Federal Communications Commission
Equipment Authorization Branch
7435 Oakland Mills Road
Columbia, MD 21046**In re : ENUSTECH.,INC**
FCC ID : TT2BHF500
Cover letter

The product is Wireless Handsfree Carkit(Equipment class: Part 15 Low Power Communication Device Transmitter).

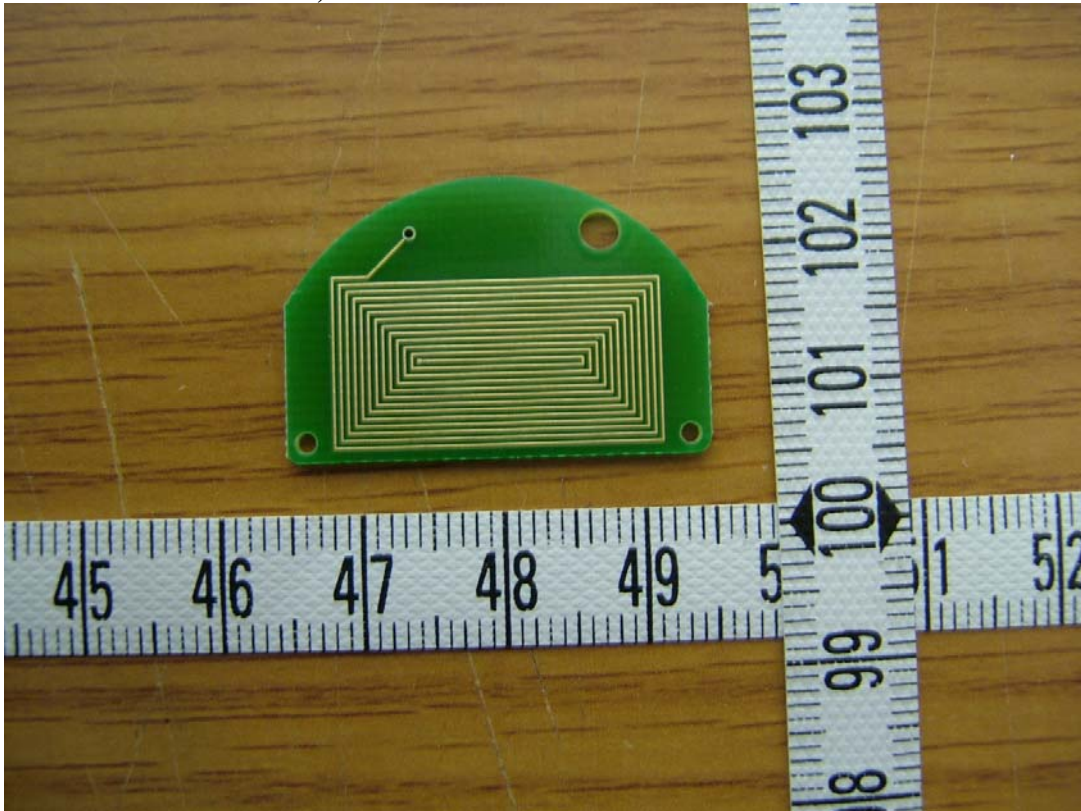
Description of change:

Before	After
FCC ID	TT2BHF500	
Model name	BHF-500	
FMT Antenna	PCB Pattern antenna	Wire antenna
Frequency Band	88.2 – 107.9MHz	88.1 – 107.9MHz

(Before : PCB Pattern antenna)

(After: Wire antenna)
